**Town of Silverthorne, Colorado**  
**Planning Commission Staff Report**

**Subject:** Minor Subdivision and Final Site Plan for Blue River Flats (PT2016-5)

# Blue River Flats

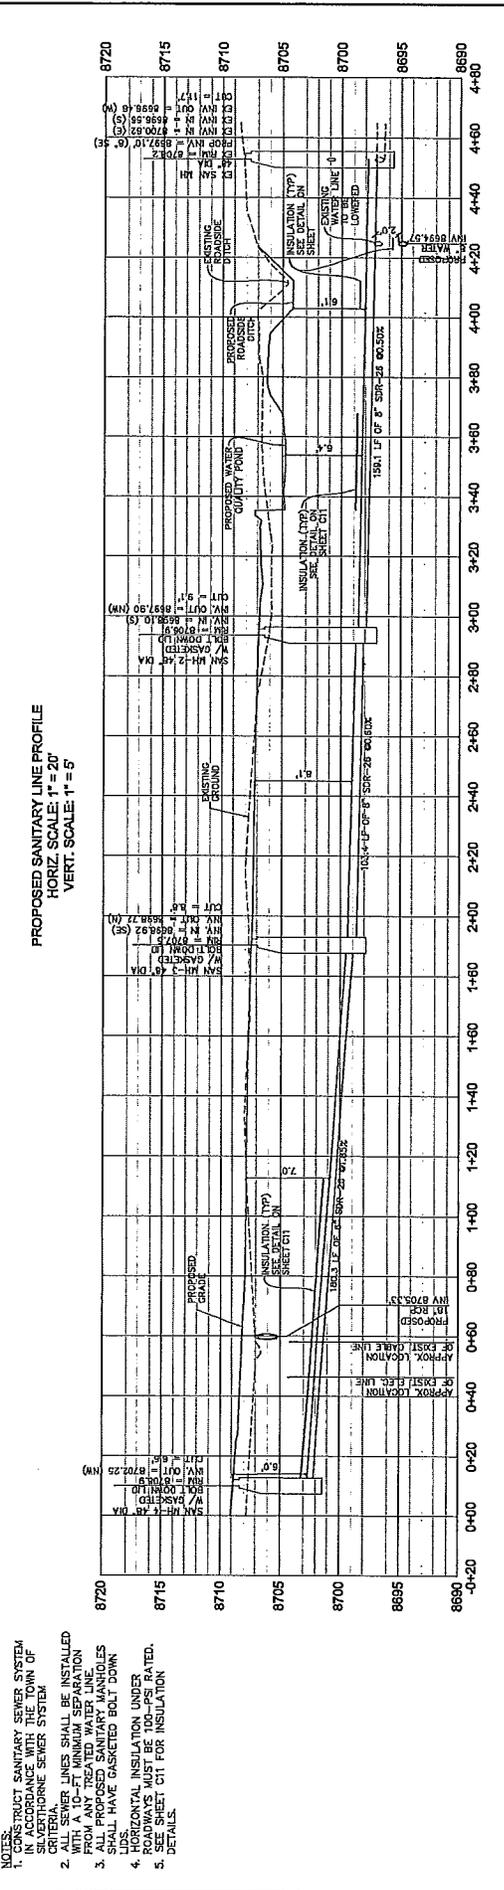
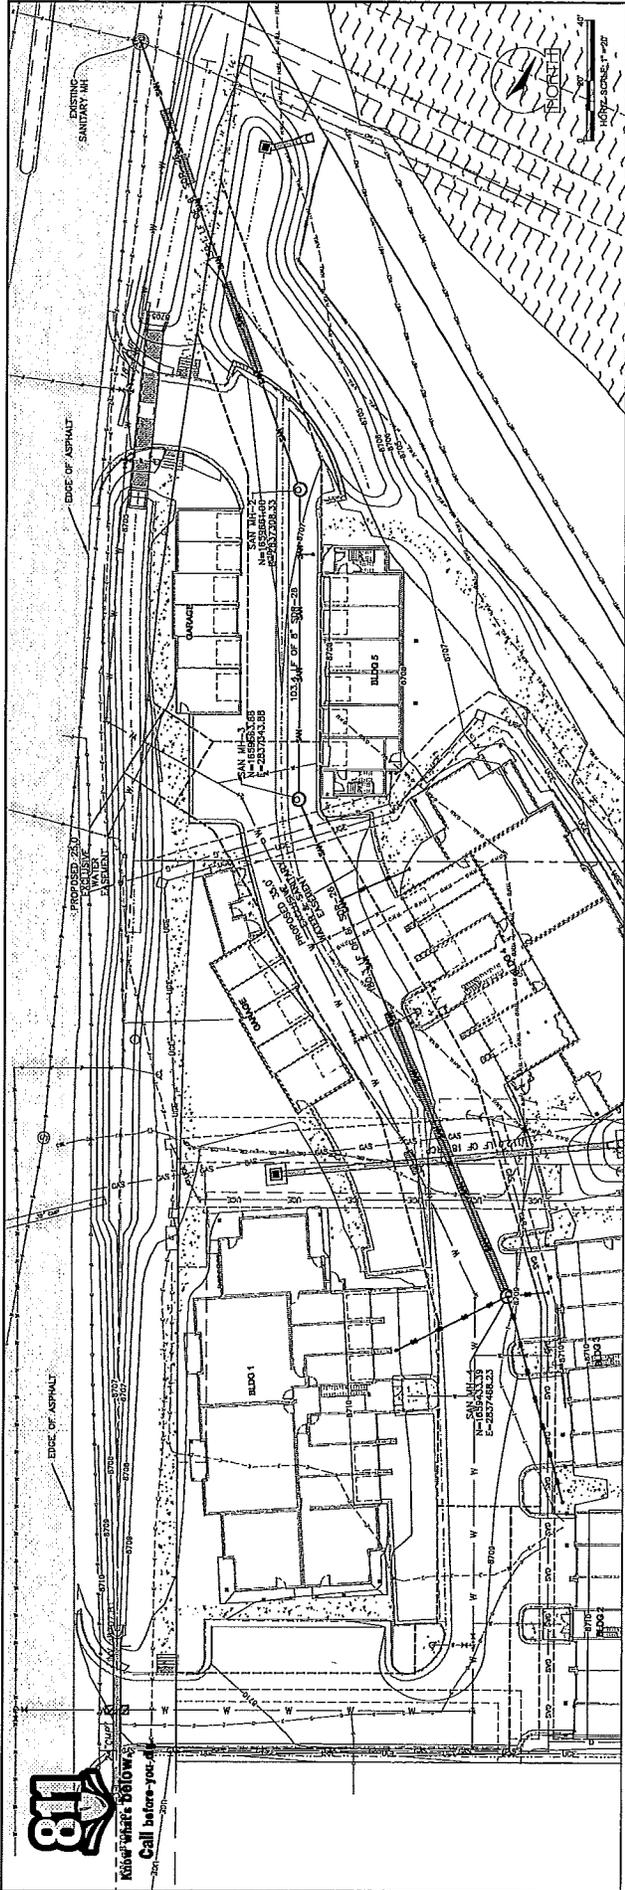
3. Sheet C2
  - a. There are two, not just one, active 8" ductile iron pipe crossings of Hwy 9 at the north end of the project, to improve reliability, this project will connect to both *RESPONSE: Comment noted.*

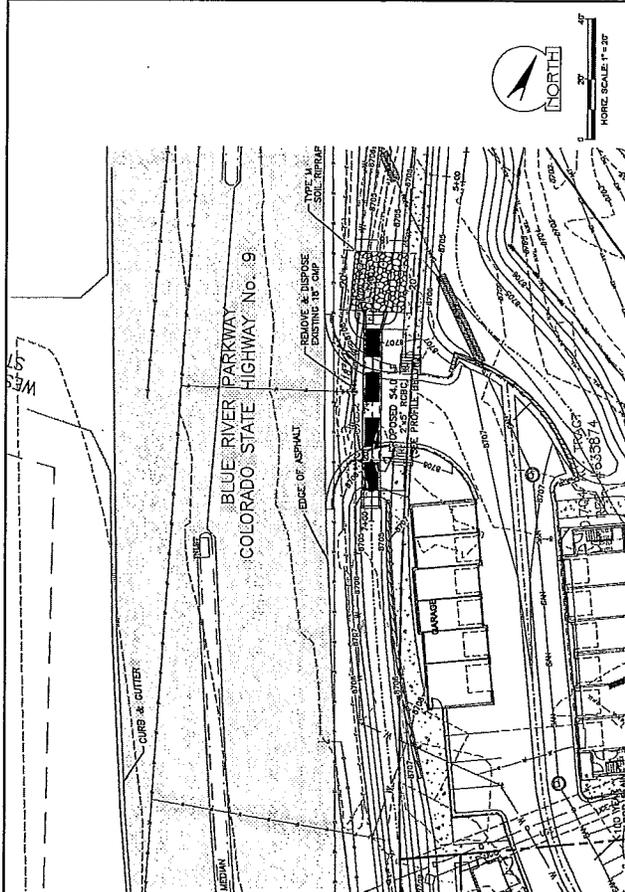
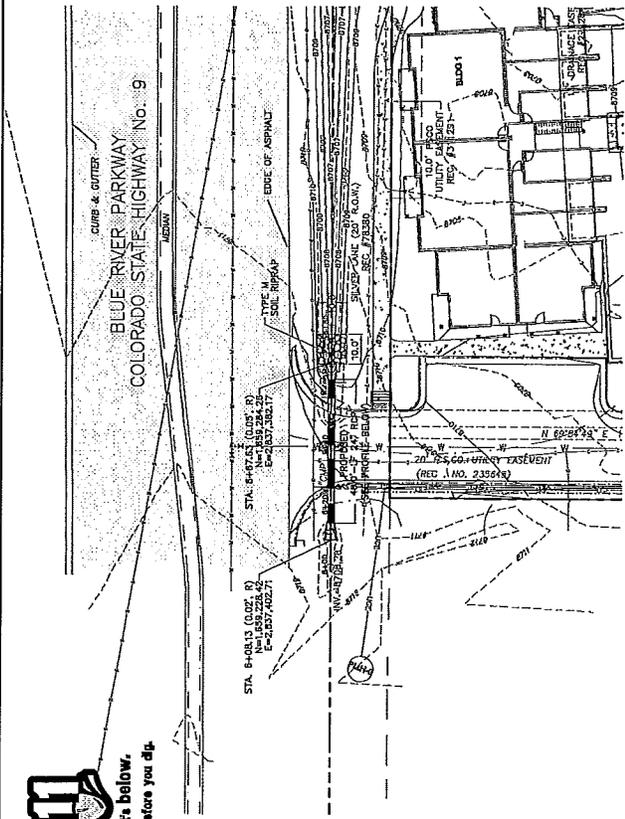
6. Sheet C11
  - a. Water Note 8: "Fire Hydrant" [we agree?] There may have been more to this note that was omitted? *RESPONSE: Note revised.*
7. Sheet L-2

SHEET TITLE:  
 LANDSCAPE  
 PLAN  
 SHEET NUMBER:  
 L-2

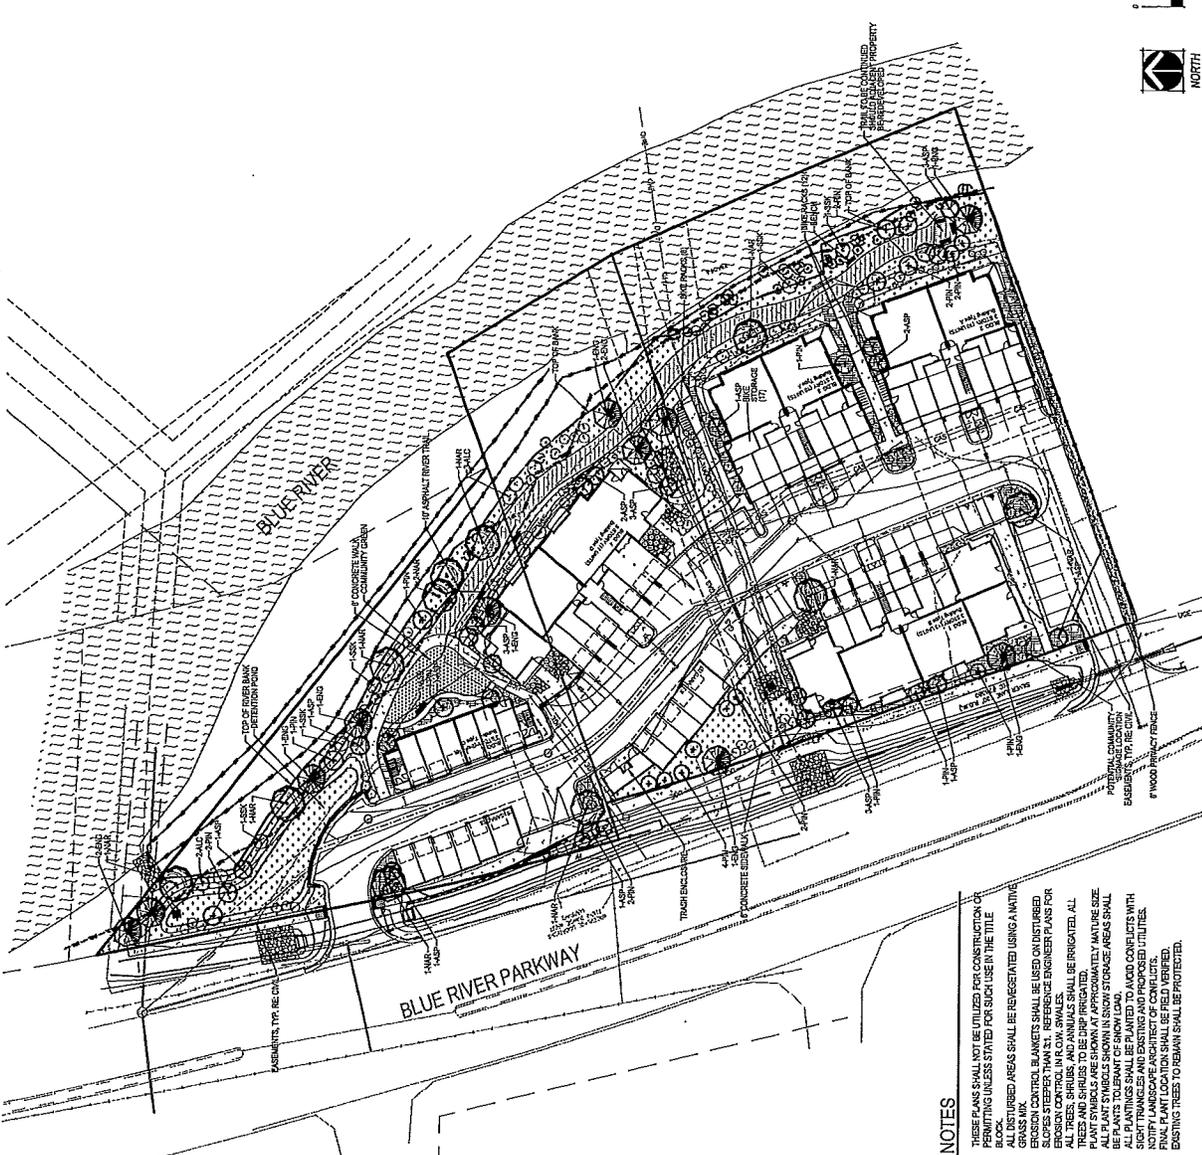
- a. Remove trees from within 10 feet of all water mains, hydrants, and sewer mains *RESPONSE: The landscape plan has been updated.*
8. Sheet L-3
  - a. No snow storage permitted within 5 feet of fire hydrants

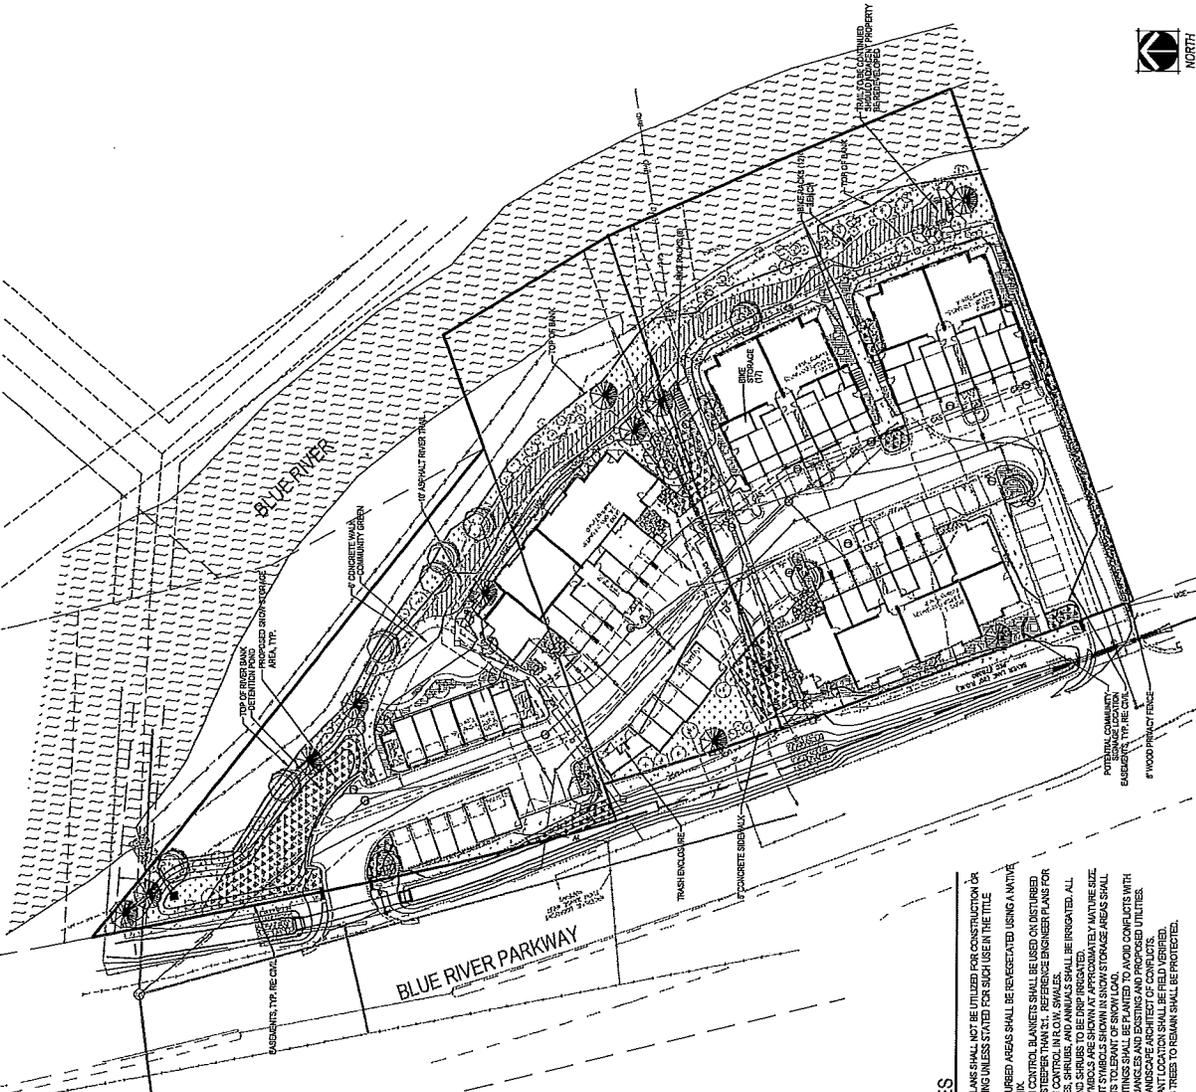
**Snow Storage** – A minimum of 25% of the total paved area must be provided for snow storage. Sheet L-3 indicates that there are 24,899 square feet of paved areas, requiring 6,114 square feet of snow storage. The applicant is proposing 6,537 square feet of snow storage in locations that facilitate the snow stacking process, meeting the requirement.
